ADDENDUM No. 1
LUC CORDUROY ROAD BRIDGE REPLACEMENT (PID 119725)

Plan holders of the City of Oregon's LUC-Corduroy Road Bridge Replacement Project (PID 119725) are hereby notified of the following amendments to the Contract Documents. The following additions, alterations, deletions and/or clarifications shall be part of the Base Bid as much as if they were originally included in the Contract Documents. This Addendum No. 1 is hereby made a part of the Contract Documents.

1) PROJECT PLANS – UPDATED SHEETS 3, 9, 13, 15, and 16.

PLAN AND PROFILE - CORDUROY RD STA 101+83.00 TO STA 104+00.05

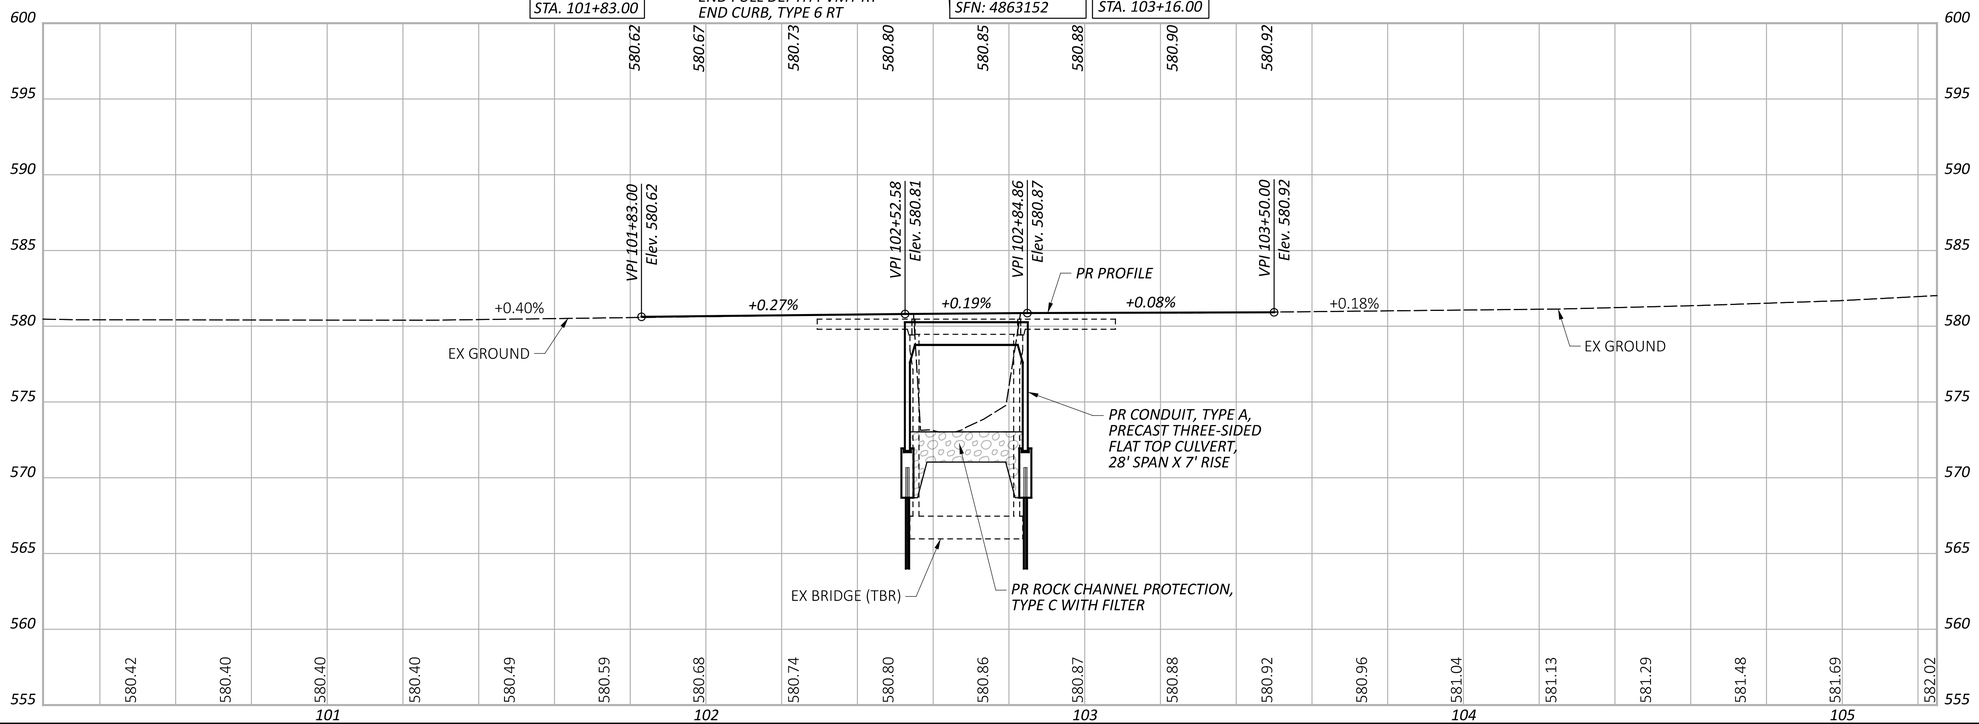
1) Elimination of the proposed new 42" × 96" elliptical pipe sections connecting into Manhole No. 5 at the southeast side of the culvert.
2) Revision of Manhole No. 5 at the southeast side to "As Per Plan," with an added note describing potential trimming of the existing 42" × 96" elliptical pipe and/or shifting of the manhole to accommodate connection to the existing elliptical pipe. All costs associated with this work are included under the manhole bid item.
3) Increase of the 66-inch conduit quantity by 4 feet to accommodate a potential shift of Manhole No. 5.
4) Revision of bid items for the 12-inch, 18-inch, and 66-inch conduits to Item 706.02, specifying reinforced concrete pipe (RCP) for all pipes outleting to wingwalls.
5) Plan revisions to remove new 42" × 96" elliptical pipe callouts and linework from the P&P and Quantities sheets.
